**RESPONSE TO DEPARTMENT QUERIES
NORTH PLOT AND SQUARE (SSD 7021)**

This letter, prepared by JBA on behalf of the proponent, sets out the responses to the queries raised in the Department of Planning and Environments (the Department) correspondence dated 3 March 2017.

Figure 1 – Three options explored

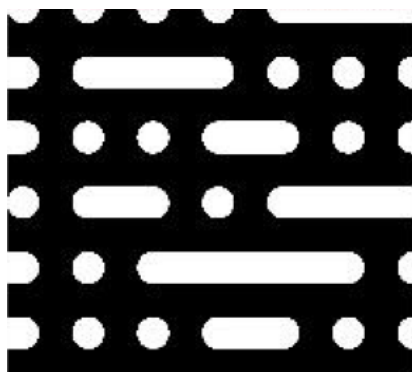
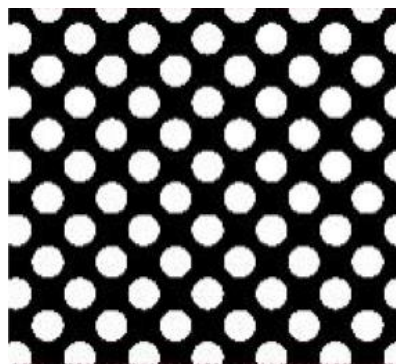
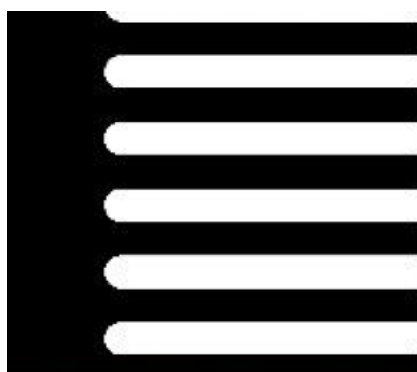
The Department has requested the following be provided in regard to the stair encroachment into the Boulevard:

- options for increasing the permeability/transparency of the step risers to increase views through the structure; and
- further justification in response to sub-point (d) of condition B4A.

KKA and Lendlease examined these three shortlisted options, evaluating how each measured against the identified factors. This assessment was informed by advice from the DDA consultant (MGAC – refer to **Attachment B**). MGAC has confirmed that all options tested would be reasonable solutions to allow a user with a vision impairment to identify the next few treads of the stairway when ascending. In testing, MGAC confirmed to the project team that no further perforation would be suitable as issues may begin to arise for a user with a vision impairment.

A structural review was also completed for each option, with all options being appropriate from a structural perspective for a civic / public stair.

Whilst each option is considered by the project team to satisfy each of the criteria, Option 2 is nominated as the preferred option given it provides the highest percentage of openness (39%). Furthermore, this option provides a simpler approach to the riser design, creating a subtle and uniform pattern which permits oblique sightlines. The consistency of the perforation across the face of the riser has increased the perceived transparency and the fineness of the perforations, creating a sense of translucence in material rather than the potential distraction of a defined and distinct pattern.

Figure 2 – Portion of stair encroachment

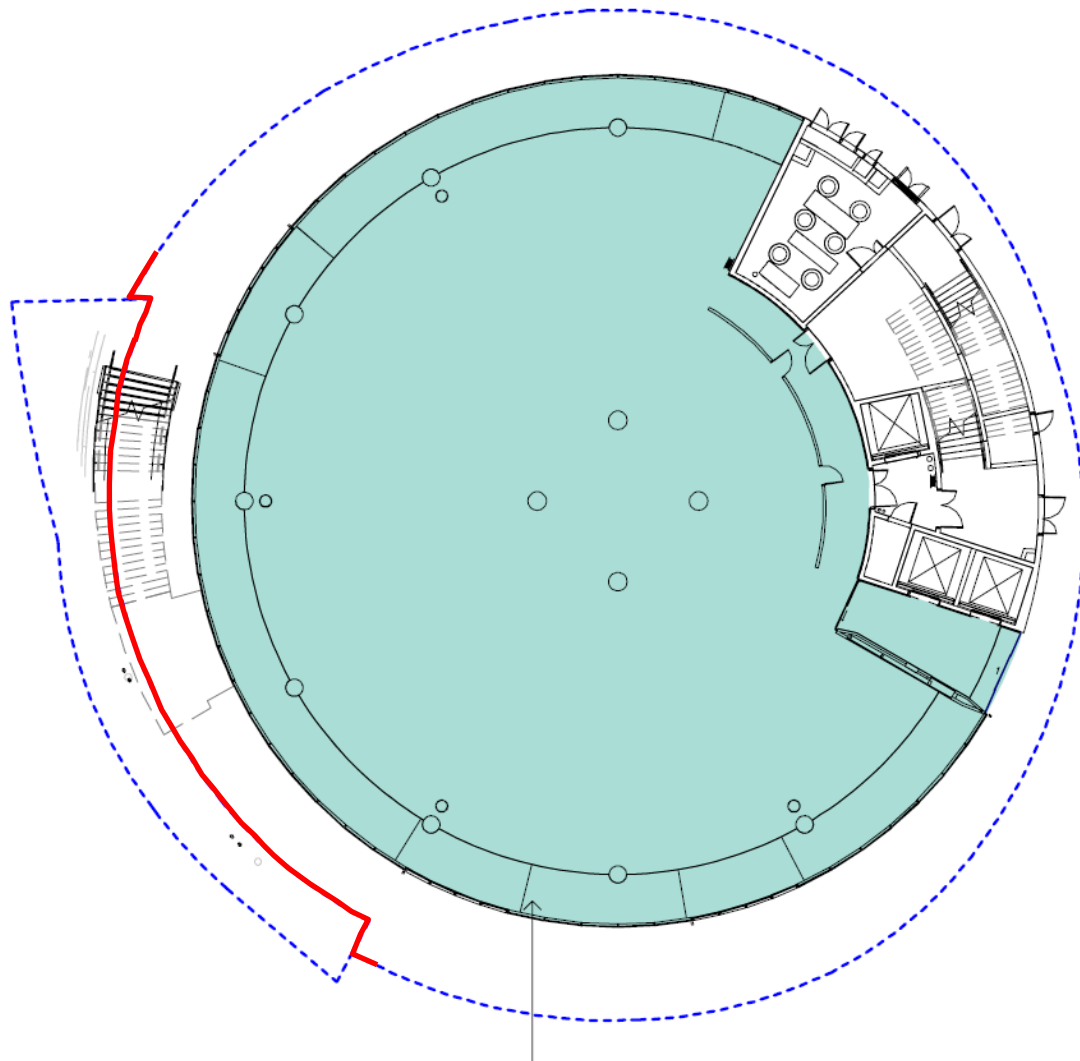
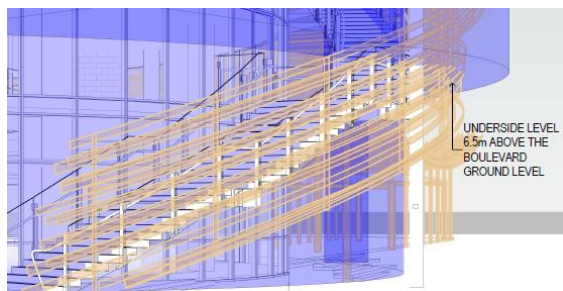
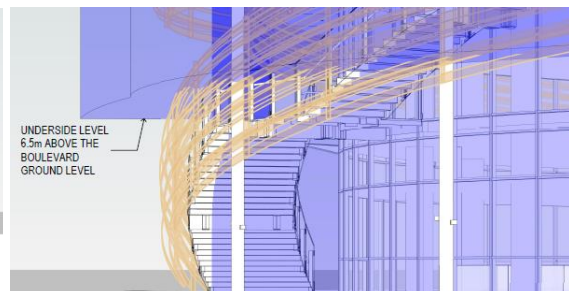
In addition to exploring options for the stair risers, the Department has requested further justification on sub-point (d) of condition B4A of development consent SSD 5878. Sub-point (d) states:

d) any encroachments are designed to be lightweight and visually permeable

To fully understand the encroachment of the stair and the achievement of a lightweight and visually permeable outcome, the extent of the encroachment must be understood. **Figure 2** provides a floor plan and several different views illustrating the extent of the encroachment. It is evident from these visualisations that the encroachment is minimal and only occurs for a portion of the stair.

- The stair risers have a transparency of 39%, with the perforated pattern containing 8mm circular openings every 8mm. This provides an open and visually permeable outcome, with varying degrees of openness as pedestrians travel through the Boulevard.

- The level of visual permeability of the stair riser is maximised in the context of DDA requirements for users with a visual impairment. The stair is visually permeable when pedestrians travel down the Boulevard, but is more opaque for users ascending the stair.

- The stair is currently designed to structurally contain only two thin lightweight columns, meaning there are limited vertical obstructions introduced into the Boulevard, in turn increasing the visual permeability of the structure. Any further reduction in the structural support of the stair stringers would require additional columns within the Boulevard, resulting in a potentially heavier and more obstructed encroachment.

- The encroachment of the stair into the Boulevard is minimal with only a small portion of the stair entering the Boulevard setback and therefore the Boulevard is largely retained as a visually unencumbered space (refer to views in **Figure 2**).
